PSE&G Public Service
Electric and Gas
Company

HOPE CREEK GENERATING STATION
DOCKET NO. 50-354
DRAFT SAFETY EVALUATION REPORT
OPEN ITEM STATUS

DSER Open Item No. 92 (DSER Section 3.9.2.2)

FIGURE 6.2-28
SHEET 1 OF 48

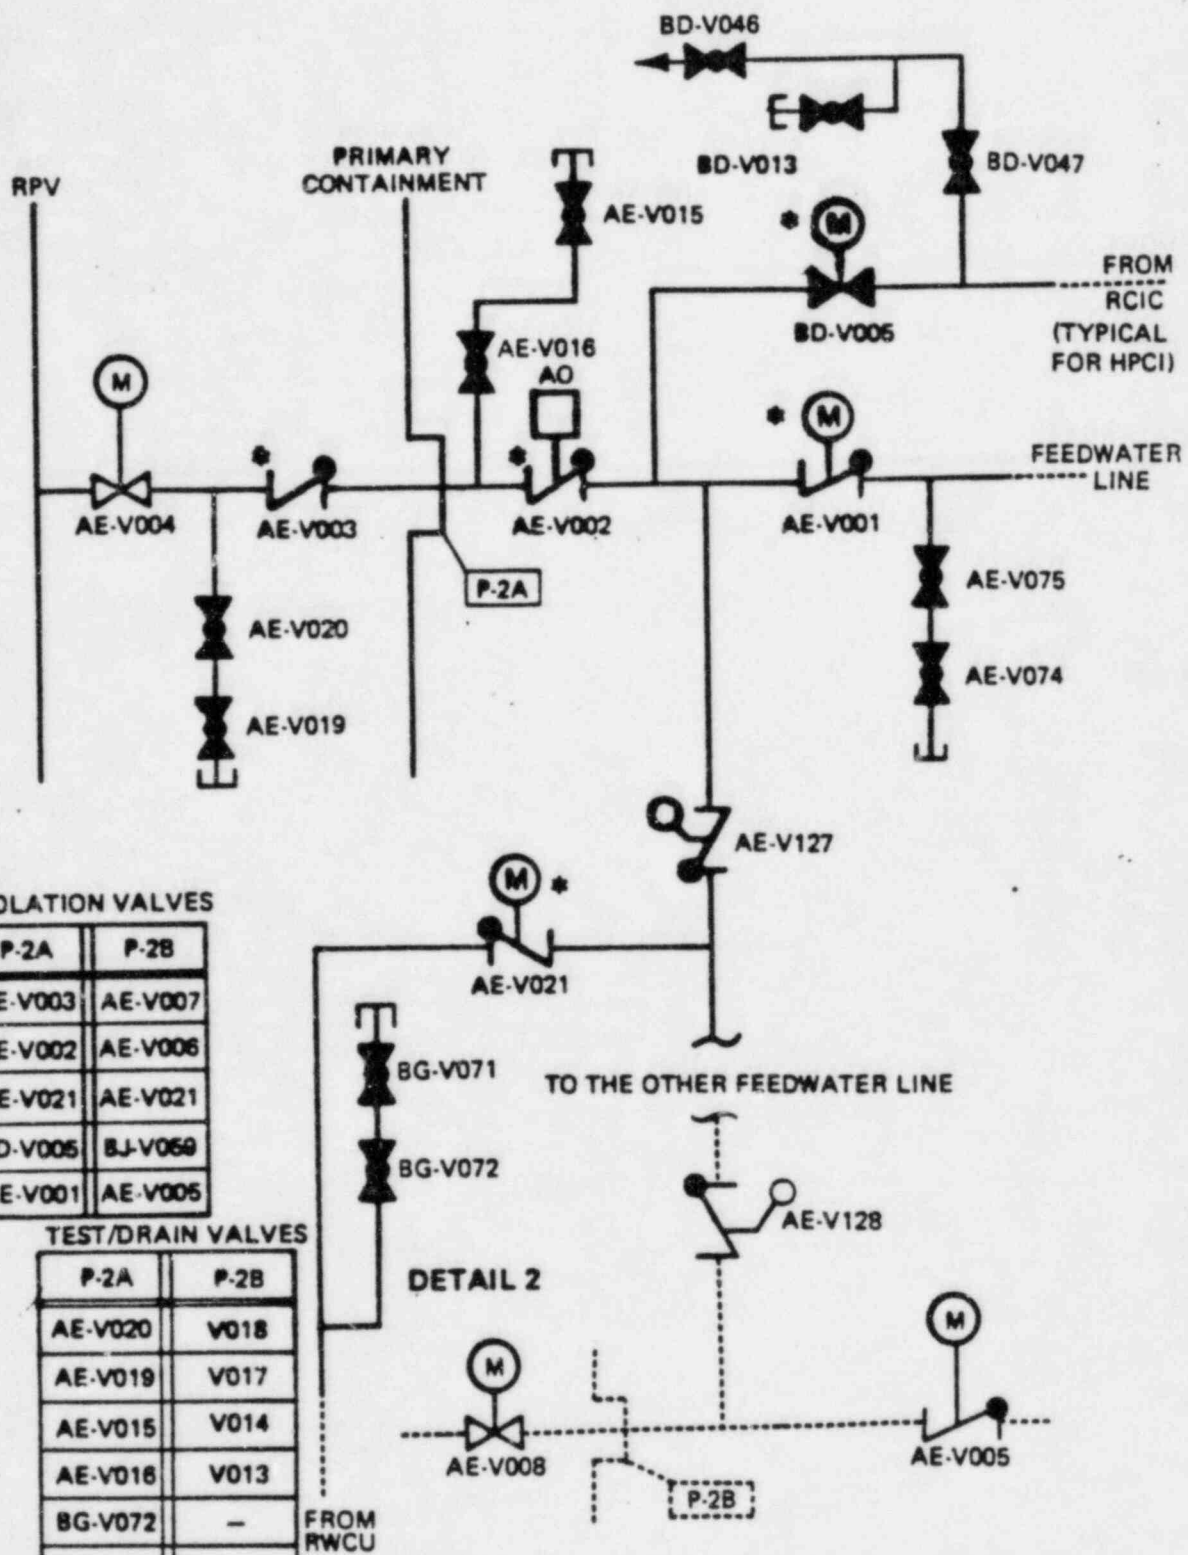
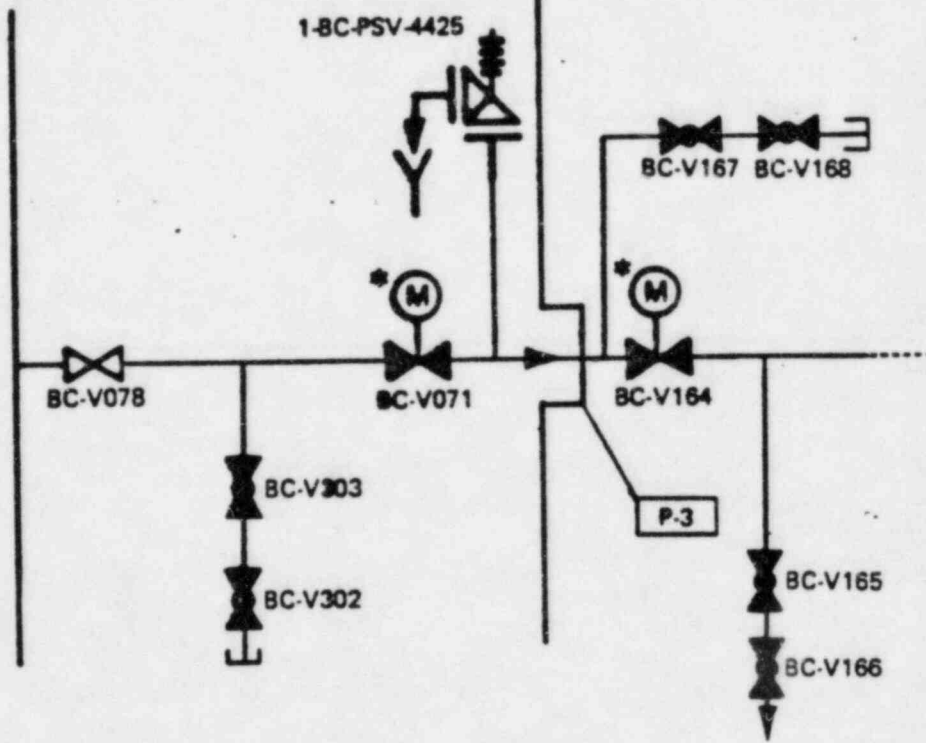
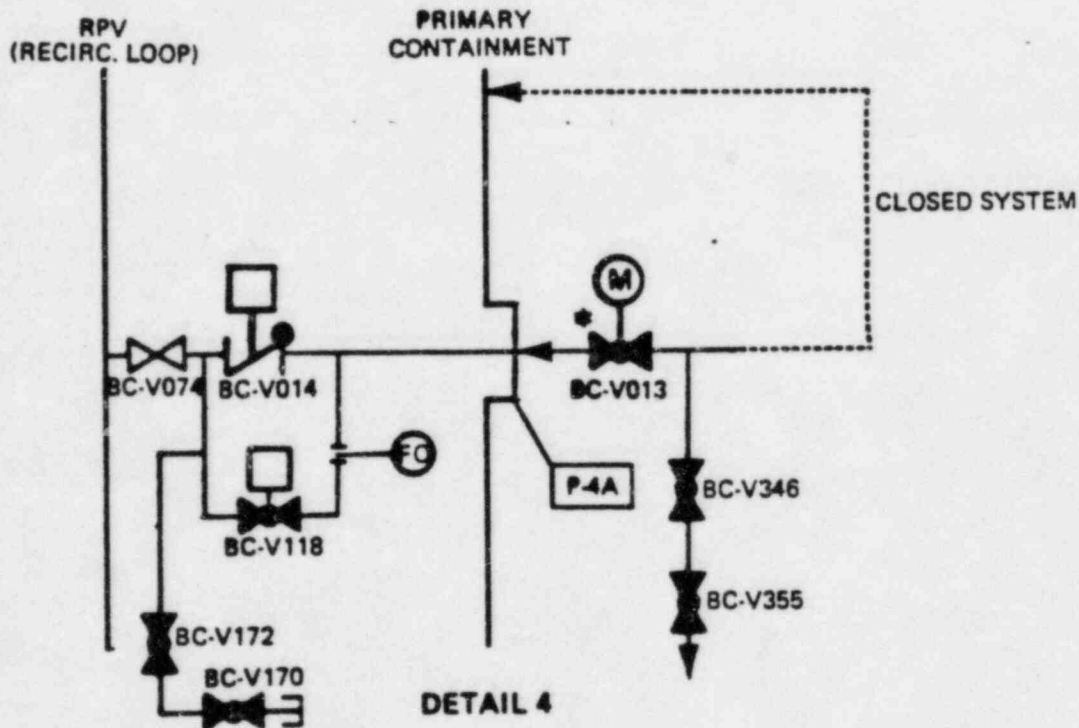
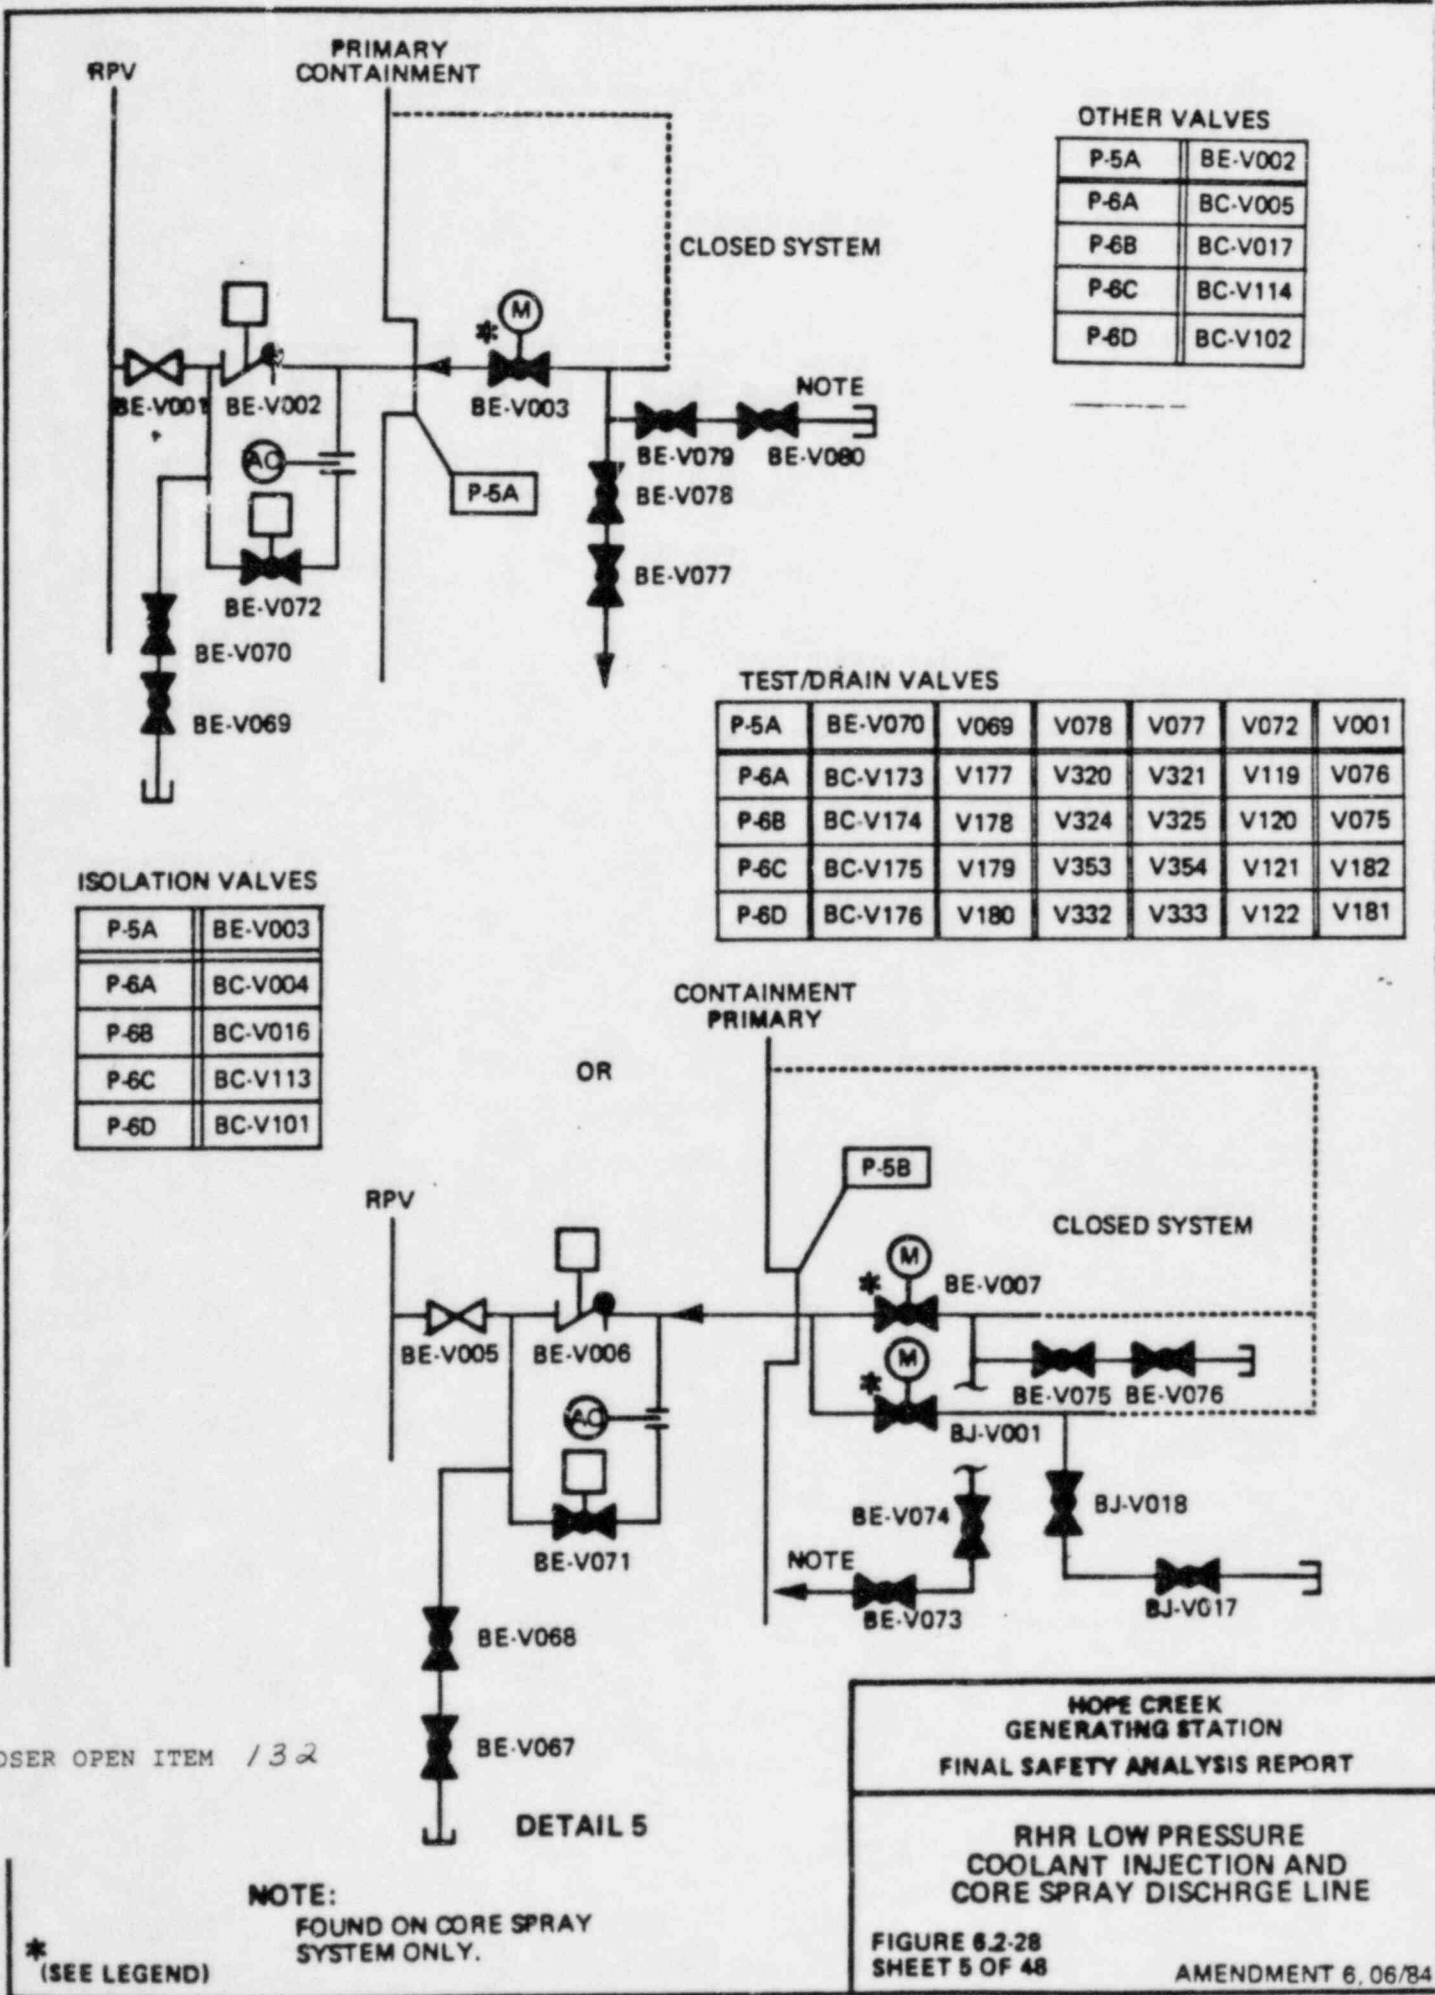
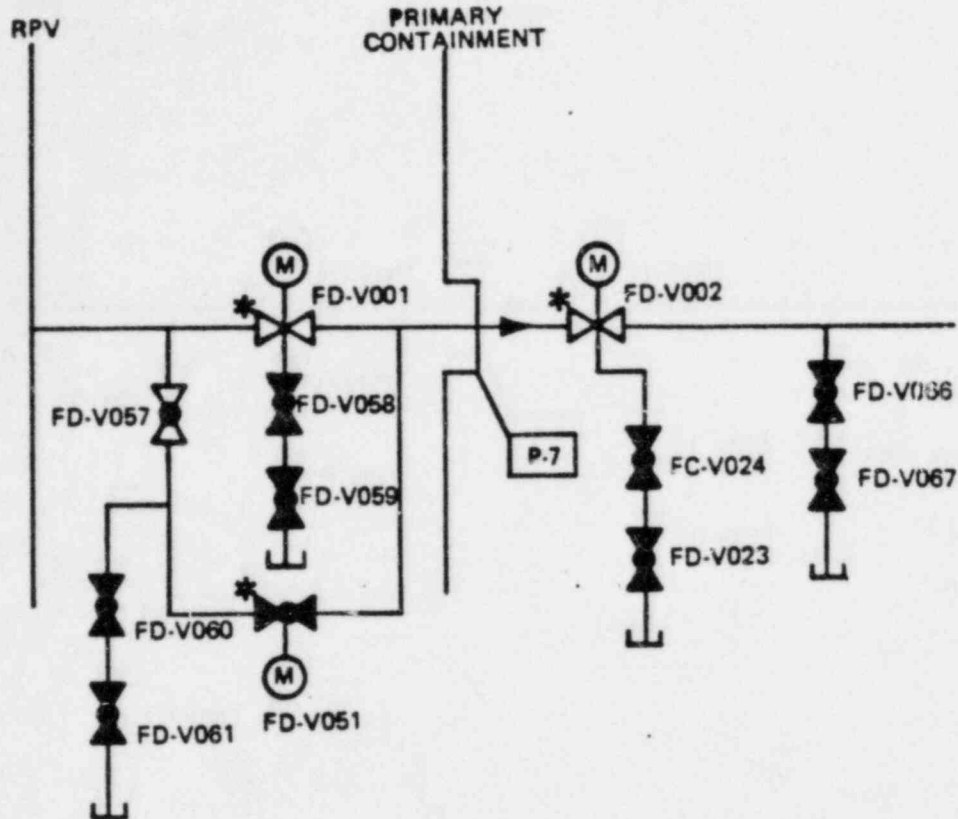
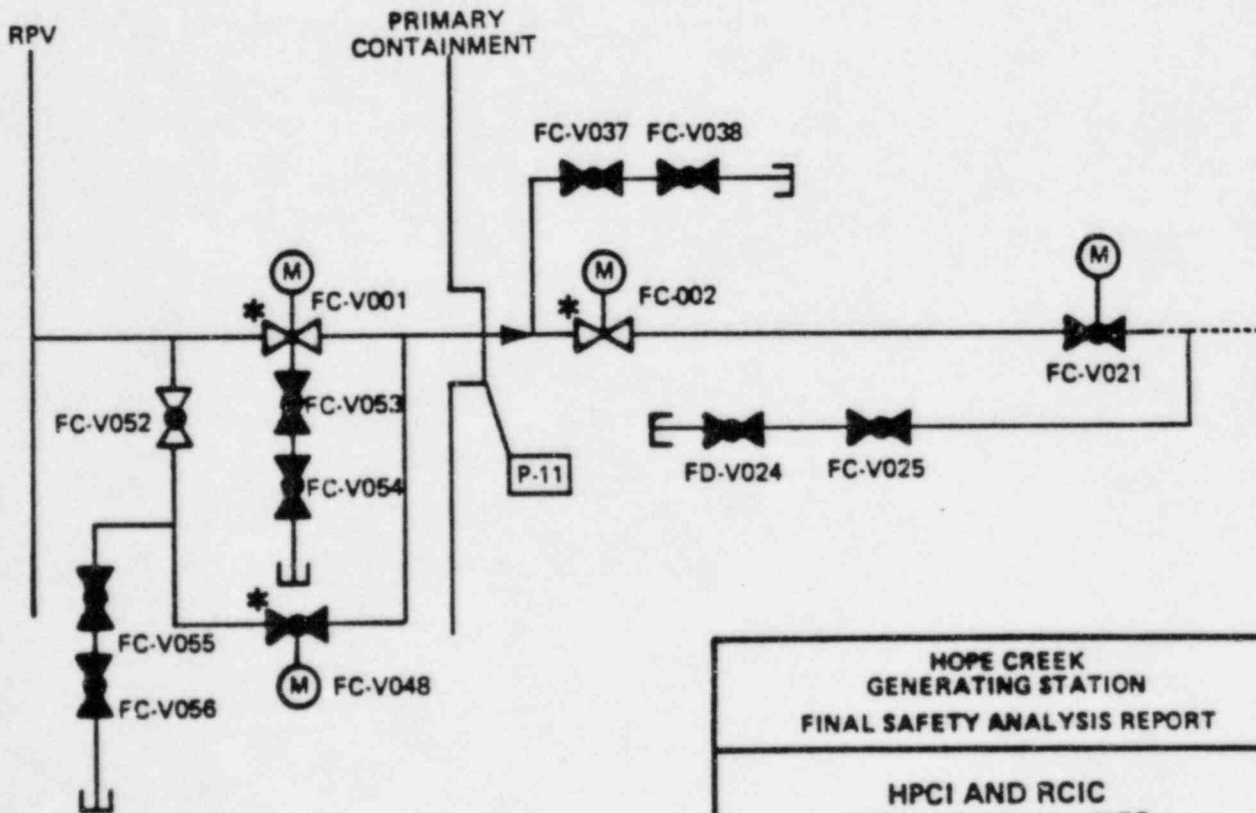
The basis for the staff's acceptance has been the conformance of the containment isolation provisions to the Commission's regulations as set forth in general design criteria and applicable regulatory guides, staff technical positions, the acceptance criteria of NUREG-0800, and industry codes and standards.

[However, the applicant has not provided the staff with the information requested to conduct the containment isolation review. We will require the applicant to provide for the containment isolation figures contained in the FSAR proper valve identification and the location of the test, vent, and drain lines on these figures. We will also require large enough P&ID drawings in order to conduct our review.] We will report on this matter in a supplement to this SER.

The penetration details in Figure 6.2-28 have been revised to show proper valve identification and the available test provisions.
